ADDENDUM No.1

JERICHO MOUNTAIN STATE PARK NEW RV CAMPGROUND

Project No. ARP 2418

July 2, 2024

C5.03

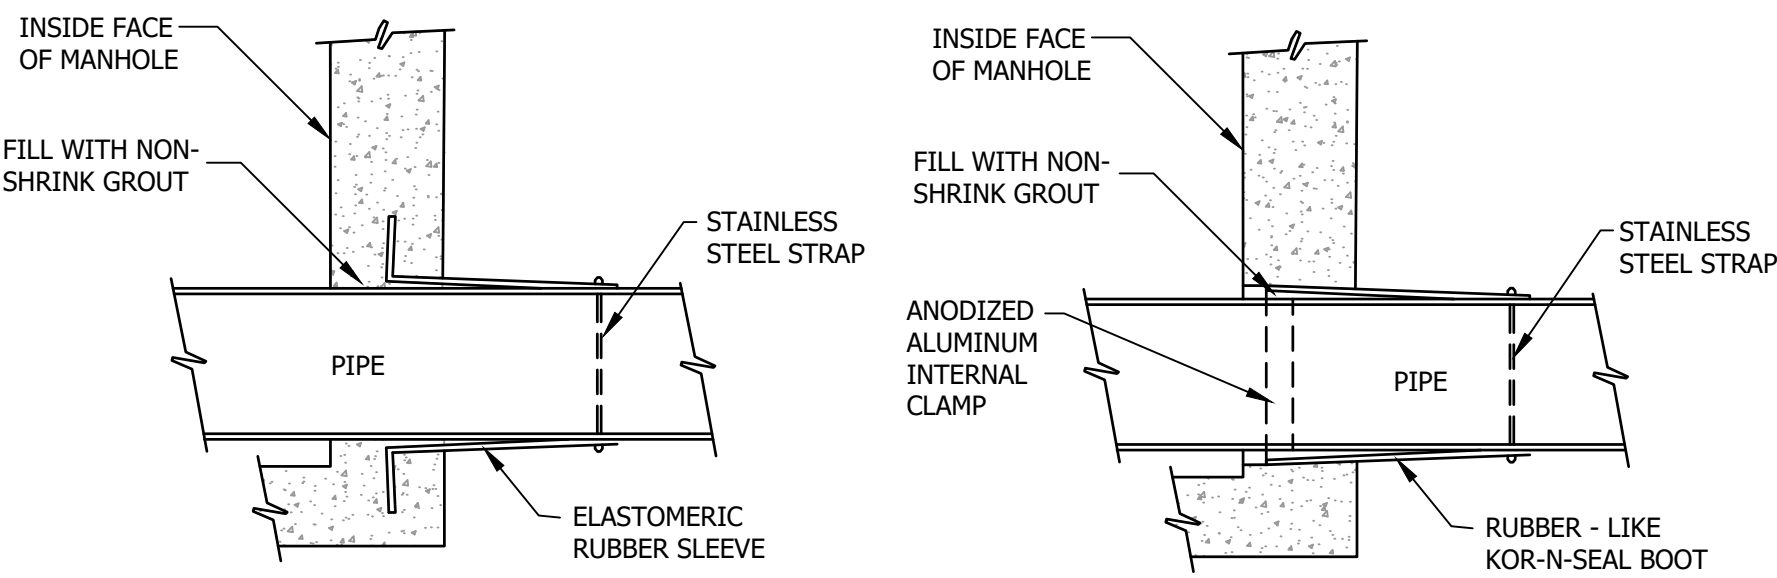
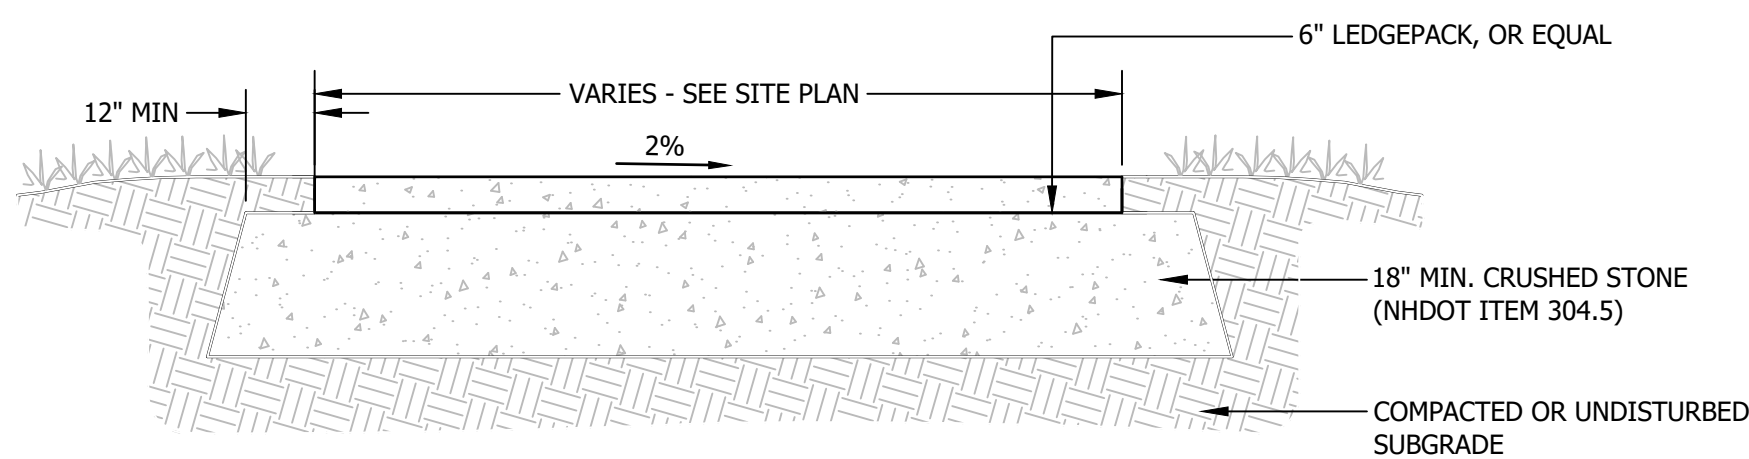
4. Question: Can you reconcile the Road Cross Section Detail and the Pavement Joining detail?
Answer: Yes. See revised sheet C5.03.
5. Question: What is the available timeline for work inside the existing campground?
